Jericho Wind, Inc.

## **Revision to the Water Assessment and Water Body Report – Jericho Wind Energy Centre**

60301207

October, 2013

Figure 2-1

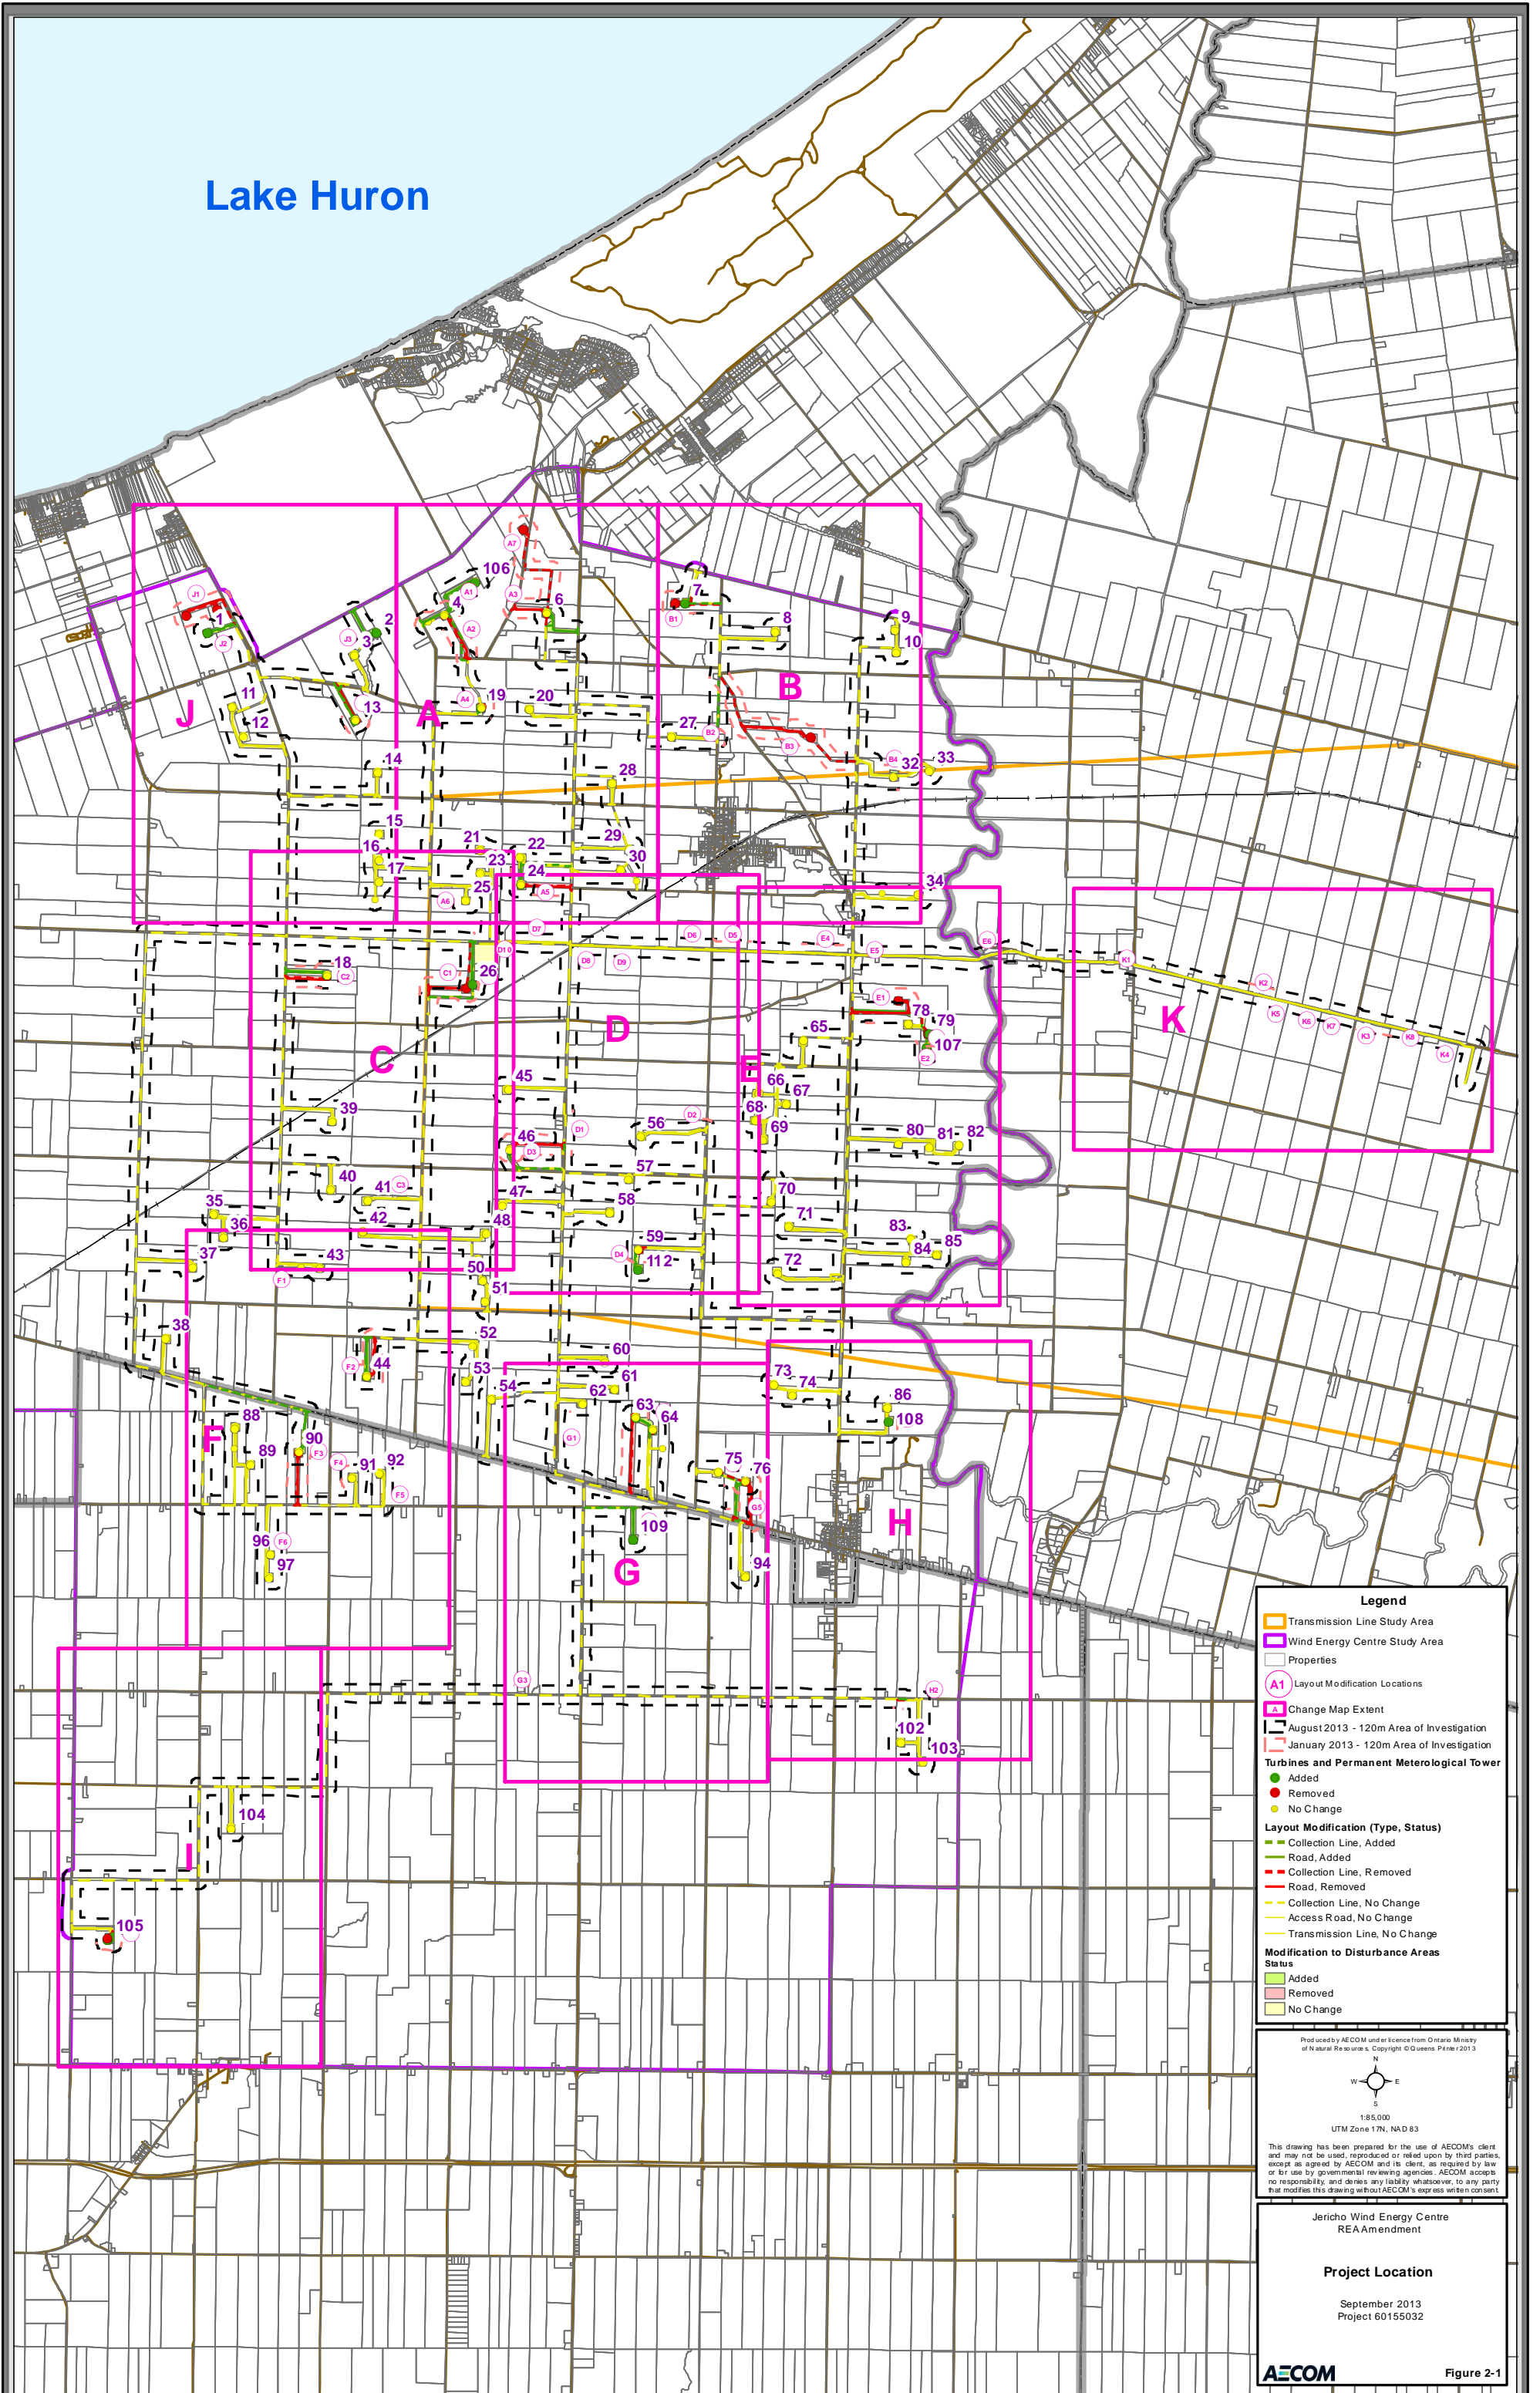
Label on Figure 2-1	Proposed Modification	Rationale for Proposed Modification	New Potential Environmental Effects <i>(related to Water Bodies)</i>	New Mitigation Measures <i>(related to Water Bodies)</i> <sup>1</sup>
A1	Addition of Turbine 106 and associated access road and collection line, extending northeast from Turbine 4.	Infrastructure or construction disturbance area added or changed to optimize project design/ constructability.	<p>Water body present within 120 m buffer of turbine and infrastructure (Feature ID R4.16-D).</p> <p><b>Turbine</b></p> <ul style="list-style-type: none"> <li>• Increase to surface water temperature from reduced groundwater contribution if dewatering activities are required for excavation of turbine foundations.</li> <li>• Increase to streamflows in watercourses that receive temporary groundwater dewatering discharge (if required). Groundwater discharge has potential to cause streambed and/or bank erosion and downstream sedimentation if not managed properly.</li> <li>• Increased erosion, sedimentation and turbidity in watercourse from clearing and grubbing on adjacent lands for construction of turbine, pad and turnaround area.</li> <li>• Soil compaction, which may result in hardening of surfaces and increased runoff into watercourses.</li> <li>• Release / discharge of runoff from the construction area, which has the potential to transport sediment and nutrients into the watercourse.</li> <li>• Soil/water contamination by oils, grease and other materials from accidental spills and release of contaminants from construction equipment.</li> <li>• Increase in impervious surfaces from presence of turbine foundation, resulting in increased water temperatures, increased surface runoff and stream peak flows, and reduced infiltration, base flows and upwelling.</li> </ul> <p><b>Access Road</b></p> <ul style="list-style-type: none"> <li>• Increased erosion, sedimentation and turbidity from clearing and grubbing for construction of access roads.</li> <li>• Soil/water contamination by oils, grease and other materials from construction equipment.</li> <li>• Release / discharge of runoff from the construction area, which has the potential to transport sediment and nutrients into the watercourse.</li> <li>• Reduction of streamflow due to the withdrawal of surface water for construction activities such as dust suppression, equipment washing and land reclamation (e.g., hydroseeding).</li> <li>• Increase in impervious surfaces from presence of access road, resulting in increased water temperatures, increased surface runoff and stream peak flows, and reduced infiltration, base flows and upwelling.</li> </ul> <p><b>Collection Line</b></p> <ul style="list-style-type: none"> <li>• Soil / water contamination by oils, gasoline, grease and other materials from accidental spills and release of contaminants from equipment.</li> <li>• Release / discharge of runoff from the construction area, which has the potential to transport sediment and nutrients into the watercourse.</li> </ul>	<p><b>Turbine</b></p> <ul style="list-style-type: none"> <li>• Timing windows</li> <li>• Erosion and sediment control</li> <li>• Grading and excavation</li> <li>• Material stockpiling and handling</li> </ul> <p><b>Access Road</b></p> <ul style="list-style-type: none"> <li>• Timing Windows</li> <li>• Erosion and sediment control</li> <li>• Grading and excavation</li> <li>• Equipment use</li> <li>• Material stockpiling and handling</li> </ul> <p><b>Collection Line</b></p> <ul style="list-style-type: none"> <li>• Equipment use</li> <li>• Erosion and sediment control</li> </ul>

A2	Relocation of access road to Turbine 4 to travel northeast from Jericho Road, and relocation of collection line to Turbine 4 near Kennedy Line.	Construction disturbance area modified to reduce or eliminate impacts to archaeological resources.	No new effects identified.	n/a
A3	Relocation of access road and collection line to Turbine 6 to travel west from Northville Road and then north to Turbine 6; relocation of Turbine 6 construction disturbance area to the north.	Construction disturbance area modified to reduce or eliminate impacts to archaeological resources.	None – no water bodies identified in the new 120 m infrastructure buffer.	n/a
A4	Relocation of Turbine 19 construction disturbance area 19 m to the southwest and addition of access road construction disturbance area near Jericho Road.	Construction disturbance area modified to reduce or eliminate impacts to archaeological resources.	No new effects identified.	n/a

A5	Removal of access road and collection line to Turbine 24, addition of access road disturbance area between Turbine 22 and Turbine 24 and relocation of collection line to the access road disturbance area for Turbine 22.	Infrastructure or construction disturbance area added or changed to optimize project design/ constructability.	<p>2 road crossings on the water body instead of 1(Feature ID R4.33-B). The potential environmental effects on the water body present in 120 m buffer and new access road crossing are listed below.</p> <p><b>Access Road</b></p> <ul style="list-style-type: none"> <li>• Obstruction of lateral flows in watercourses from water crossings.</li> <li>• Temporary disruption of substrates/habitat at locations where in-water work is required (culvert installations).</li> <li>• Degradation of fish habitat from culvert installation.</li> <li>• Increased erosion, sedimentation and turbidity from clearing and grubbing for construction of access roads.</li> <li>• Soil/water contamination by oils, grease and other materials from construction equipment.</li> <li>• Release / discharge of runoff from the construction area, which has the potential to transport sediment and nutrients into the watercourse.</li> <li>• Reduction of streamflow due to the withdrawal of surface water for construction activities such as dust suppression, equipment washing and land reclamation (e.g., hydroseeding).</li> <li>• Increase in impervious surfaces from presence of access road, resulting in increased water temperatures, increased surface runoff and stream peak flows, and reduced infiltration, base flows and upwelling.</li> <li>• Soil/water contamination by oils, grease and other materials from maintenance activities.</li> <li>• Obstruction of lateral flows in watercourses and other water bodies due to design of culverts and debris build-up at water crossings.</li> </ul>	<p><b>Access Road</b></p> <ul style="list-style-type: none"> <li>• Culvert Design</li> <li>• Isolated crossing</li> <li>• Timing Windows</li> <li>• Erosion and sediment control</li> <li>• Grading and excavation</li> <li>• Equipment use</li> <li>• Material stockpiling and handling</li> <li>• Water quality</li> <li>• Water management</li> <li>• Rehabilitation</li> </ul>

<b>Label on Figure 2-1</b>	<b>Proposed Modification</b>	<b>Rationale for Proposed Modification</b>	<b>New Potential Environmental Effects (related to Water Bodies)</b>	<b>New Mitigation Measures (related to Water Bodies)<sup>1</sup></b>
<b>A6</b>	Removal of a portion of construction disturbance area for access road and collection line to Turbines 21, 23 and 25.	Construction disturbance area modified to reduce or eliminate impacts to archaeological resources.	No new effects identified.	n/a
<b>A7</b>	Removal of Turbine 5 and associated access road and collection line.	Turbine and associated infrastructure removed.	None – removal of turbine and infrastructure.	n/a
<b>B1</b>	Relocation of Turbine 7 and associated construction disturbance area 148 m to the east.	Infrastructure or construction disturbance area added or changed to optimize project design/ constructability.	No new effects identified.	n/a

<b>B2</b>	Addition of collection line in Gordon Road right-of-way, north of the road to Turbine 27.	Infrastructure or construction disturbance area added or changed to optimize project design/ constructability.	Water body present in 120 m buffer of collection line and within collection line crossing (Feature ID R3-C-1). <b>Collection Line</b> <ul style="list-style-type: none"> <li>• Release of pressurized drilling fluids into watercourses from fractures in substrate (also known as a 'frac-out').</li> <li>• Change to groundwater flow patterns which may affect groundwater discharge to watercourses.</li> <li>• Increase in erosion and sedimentation from the entry and exit drill holes required for the directional drilling activities. This will require clearing and grubbing of the land and removal of substrates from the drill hole.</li> <li>• Soil / water contamination by oils, gasoline, grease and other materials from accidental spills and release of contaminants from equipment.</li> <li>• Release / discharge of runoff from the construction area, which has the potential to transport sediment and nutrients into the watercourse.</li> </ul>	<b>Collection Line</b> <ul style="list-style-type: none"> <li>• Directional drilling</li> <li>• Water quality</li> <li>• Water management</li> <li>• Erosion and sediment control</li> </ul>

<b>B3</b>	Removal of Turbine 31 and associated access road and collection line.	Turbine and associated infrastructure removed.	None – removal of turbine and infrastructure.	
<b>B4</b>	Addition of Turbine 32 construction disturbance area 34 m to the north and removal of the southeast portion of construction disturbance area.	Construction disturbance area modified to reduce or eliminate impacts to archaeological resources.	None – no water bodies identified in the new 120 m infrastructure buffer.	
<b>C1</b>	Relocation of Turbine 26 and associated construction disturbance area 101 m east. Access road relocated to travel north through the substation construction disturbance area and collection line relocated to the southern property boundary; and addition of construction disturbance area in Thompson Line right-of-way.	Infrastructure or construction disturbance area added or changed to optimize project design/ constructability.	Water body present in 120 m buffer of access road, and 120 m buffer of collection line and collection line crossing (Feature ID R4.16-A). <b>Access Road</b> <ul style="list-style-type: none"> <li>• Increased erosion, sedimentation and turbidity from clearing and grubbing for construction of access road.</li> <li>• Soil/water contamination by oils, grease and other materials from construction equipment.</li> <li>• Release / discharge of runoff from the construction area, which has the potential to transport sediment and nutrients into the watercourse.</li> <li>• Reduction of streamflow due to the withdrawal of surface water for construction activities such as dust suppression, equipment washing and land reclamation (e.g., hydroseeding).</li> <li>• Increase in impervious surfaces from presence of access road, resulting in increased water temperatures, increased surface runoff and stream peak flows, and reduced infiltration, base flows and upwelling.</li> <li>• Soil/water contamination by oils, grease and other materials from maintenance activities.</li> </ul> <b>Collection Line</b> <ul style="list-style-type: none"> <li>• Release of pressurized drilling fluids into watercourses from fractures in substrate (also known as a 'frac-out').</li> <li>• Change to groundwater flow patterns which may affect groundwater discharge to watercourses.</li> <li>• Increase in erosion and sedimentation from the entry and exit drill holes required for the directional drilling activities. This will require clearing and grubbing of the land and removal of substrates from the drill hole.</li> <li>• Soil / water contamination by oils, gasoline, grease and other materials from accidental spills and release of contaminants from equipment.</li> <li>• Release / discharge of runoff from the construction area, which has the potential to transport sediment and nutrients into the watercourse.</li> </ul>	<b>Access Road</b> <ul style="list-style-type: none"> <li>• Timing windows</li> <li>• Erosion and sediment control</li> <li>• Grading and excavation</li> <li>• Equipment use</li> <li>• Material stockpiling and handling</li> <li>• Water quality</li> <li>• Water management</li> </ul> <b>Collection Line</b> <ul style="list-style-type: none"> <li>• Directional drilling</li> <li>• Water quality</li> <li>• Water management</li> <li>• Erosion and sediment control</li> </ul>

<b>C2</b>	Relocation of access road to Turbine 18 31 m to the north.	Construction disturbance area modified to reduce or eliminate impacts to archaeological resources.	None – no water bodies identified in the new 120 m infrastructure buffer.	n/a
<b>C3</b>	Addition of construction disturbance area for access road and collection line to Turbine 41.	Infrastructure or construction disturbance area added or changed to optimize project design/ constructability.	No new effects identified.	n/a
<b>C4</b>	Addition of a spare 170 mVA transformer to be stored within the existing footprint of the Jericho substation.	Infrastructure or construction disturbance area added or changed to optimize project design/ constructability.	No new effects identified.	n/a
<b>D1</b>	Addition of construction disturbance area in the Northville Road right-of-way in two locations for collection line between Turbines 45 and 46.	New infrastructure or construction disturbance area added or changed to optimize project design/ constructability.	None – no water bodies identified in the new 120 m infrastructure buffer.

<b>D2</b>	Removal of a portion of construction disturbance area for access road and collection line to Turbine 56.	Construction disturbance area modified to reduce or eliminate impacts to archaeological resources.	No new effects identified.	n/a

Label on Figure 2-1	Proposed Modification	Rationale for Proposed Modification	New Potential Environmental Effects <i>(related to Water Bodies)</i>	New Mitigation Measures <i>(related to Water Bodies)<sup>1</sup></i>
D3	Relocation of Turbine 46 access road to travel north from Cedar Point Line and collection to travel east along the southern property boundary; and addition of construction disturbance area for collection line in the Northville Road right-of-way.	Construction disturbance area modified to reduce or eliminate impacts to archaeological resources.	<p>Water body present in 120 m buffer for access road and collection line (Feature ID R4E and R4D).</p> <p><b>Access Road</b></p> <ul style="list-style-type: none"> <li>Increased erosion, sedimentation and turbidity from clearing and grubbing for construction of access road.</li> <li>Soil/water contamination by oils, grease and other materials from construction equipment.</li> <li>Release / discharge of runoff from the construction area, which has the potential to transport sediment and nutrients into the watercourse.</li> <li>Reduction of streamflow due to the withdrawal of surface water for construction activities such as dust suppression, equipment washing and land reclamation (e.g., hydroseeding).</li> <li>Increase in impervious surfaces from presence of access road, resulting in increased water temperatures, increased surface runoff and stream peak flows, and reduced infiltration, base flows and upwelling.</li> </ul> <p><b>Collection Line</b></p> <ul style="list-style-type: none"> <li>Increase in erosion and sedimentation from the entry and exit drill holes required for the directional drilling activities. This will require clearing and grubbing of the land and removal of substrates from the drill hole.</li> <li>Soil / water contamination by oils, gasoline, grease and other materials from accidental spills and release of contaminants from equipment.</li> <li>Release / discharge of runoff from the construction area, which has the potential to transport sediment and nutrients into the watercourse.</li> </ul>	<p><b>Access Road</b></p> <ul style="list-style-type: none"> <li>Erosion and sediment control</li> <li>Grading and excavation</li> <li>Equipment use</li> <li>Material stockpiling and handling</li> <li>Water quality</li> <li>Timing windows</li> <li>Water management</li> </ul> <p><b>Collection Line</b></p> <ul style="list-style-type: none"> <li>Erosion and sediment control</li> <li>Water management</li> <li>Equipment use</li> <li>Water quality</li> </ul>

D4	Addition of Turbine 112 and associated access road and collection line, extending south from Turbine 59.	New infrastructure or construction disturbance area added or changed to optimize project design/ constructability.	None – no water bodies identified in the new 120 m infrastructure buffer.	n/a
D5	Addition of construction disturbance area on private property to the north of Thomson Line to allow for installation of collection line and/or transmission line.	New infrastructure or construction disturbance area added or changed to optimize project design/ constructability.	None – no water bodies identified in the new 120 m infrastructure buffer.	n/a
D6	Addition of transmission line construction disturbance area on private property to allow for transmission line installation either in the Thomson Line right-of-way or on private property, within the disturbance area proposed to host collection line.	New infrastructure or construction disturbance area added or changed to optimize project design/ constructability.	No new effects identified.	n/a

D7	Addition of collection line disturbance area on private property to allow for collection line installation either in the Thomson Line right-of-way or on private property, within the disturbance area proposed to host the transmission line.	New infrastructure or construction disturbance area added or changed to optimize project design/ constructability.	No new effects identified.	n/a
D8	Addition of collection line disturbance area on private property to allow for collection line installation either in the Thomson Line right-of-way or on private property, within the disturbance area proposed to host the transmission line.	New infrastructure or construction disturbance area added or changed to optimize project design/ constructability.	None – no water bodies identified in the new 120 m infrastructure buffer.	n/a
D9	Addition of collection line disturbance area on private property to allow for collection line installation either in the Thomson Line right-of-way or on private property, within the disturbance area proposed to host the transmission line.	New infrastructure or construction disturbance area added or changed to optimize project design/ constructability.	No new effects identified.	n/a

D10	Relocation of transmission line construction disturbance area within natural areas located in the Thomson Line right-of-way.	Infrastructure or construction disturbance area added or changed to optimize project design/ constructability.	No new effects identified.	n/a
E1	Removal of Turbine 77 and associated access road and collection line / Removal and addition of portions of construction disturbance area for access road and collection line to Turbines 78, 79 and 107.	Turbine and associated infrastructure removed / Construction disturbance area modified to reduce or eliminate impacts to archaeological resources.	No new effects identified.	n/a
E2	Addition of Turbine 107 and associated access road and collection line, extending south from Turbine 79.	Infrastructure or construction disturbance area added or changed to optimize project design/ constructability.	None – no water bodies identified in the new 120 m infrastructure buffer.	n/a

E3	Relocation of Turbine 79 23 m to the east, within existing turbine construction disturbance area.	Construction disturbance area modified to reduce or eliminate impacts to archaeological resources.	No new effects identified.	n/a
E4	Addition of construction disturbance area on private property to the north of Thomson Line to allow for installation of collection line and/or transmission line.	Infrastructure or construction disturbance area added or changed to optimize project design/ constructability.	None – no water bodies identified in the new 120 m infrastructure buffer.	n/a
E5	Relocation of transmission line construction disturbance area within natural areas located in the Thomson Line road right-of-way.	Infrastructure or construction disturbance area added or changed to optimize project design/ constructability.	None – no water bodies identified in the new 120 m infrastructure buffer.	n/a

E6	Relocation of transmission line construction disturbance area within natural areas located in the Thomson Line/Elginfield Road right-of-way.	Infrastructure or construction disturbance area added or changed to optimize project design/ constructability.	None – no water bodies identified in the new 120 m infrastructure buffer.	n/a

Label on Figure 2-1	Proposed Modification	Rationale for Proposed Modification	New Potential Environmental Effects (related to Water Bodies)	New Mitigation Measures (related to Water Bodies) <sup>1</sup>
F1	Removal of a portion of construction disturbance area for access road and collection line to Turbine 43.	Construction disturbance area modified to reduce or eliminate impacts to archaeological resources.	No new effects identified.	n/a
F2	Relocation of Turbine 44 access road 32 m to the west.	Construction disturbance area modified to reduce or eliminate impacts to archaeological resources.	No new effects identified.	n/a
F3	Relocation of Turbine 90 access road and collection line to the north, extending to Townsend Line and addition of collection line in the Townsend Line right-of-way.	Construction disturbance area modified to reduce or eliminate impacts to archaeological resources.	None – no water bodies identified in the new 120 m infrastructure buffer.	n/a

F4	Addition of Turbine 91 construction disturbance area 17 m to the west.	Infrastructure or construction disturbance area added or changed to optimize project design/ constructability.	No new effects identified.	n/a
F5	Removal of a portion of construction disturbance area for access road and collection line to Turbine 92.	Construction disturbance area modified to reduce or eliminate impacts to archaeological resources.	No new effects identified.	n/a
F6	Removal of a portion of construction disturbance area for access road and collection line to Turbines 96 and 97.	Construction disturbance area modified to reduce or eliminate impacts to archaeological resources.	No new effects identified.	n/a
G1	Addition of Turbine 62 construction disturbance area to the west and addition of collection line disturbance area in two locations in the Northville Road right-of-way.	Infrastructure or construction disturbance area added or changed to optimize project design/ constructability.	No new effects identified.	n/a

G2	Removal of the road and collection line to Turbine 63 and addition of road and collection line, extending west from Turbine 64 to Turbine 63.	Construction disturbance area modified to reduce or eliminate impacts to archaeological resources.	None – no water bodies identified in the new 120 m infrastructure buffer.	n/a
G3	Removal of collection line construction disturbance area north of Birnam Line.	Infrastructure or construction disturbance area added or changed to optimize project design/ constructability.	None – no water bodies identified in the new 120 m infrastructure buffer.	n/a
G4	Relocation of collection line between Turbines 76 and 75 20 m to the south.	Construction disturbance area modified to reduce or eliminate impacts to archaeological resources.	None – no water bodies identified in the new 120 m infrastructure buffer.	
G5	Relocation of Turbine 76 access road and collection line 134 m to the west.	Construction disturbance area modified to reduce or eliminate impacts to archaeological resources.	No new effects identified. Removal of water body from 120 m infrastructure buffer however, 2 ponds remain in 120 m buffer.
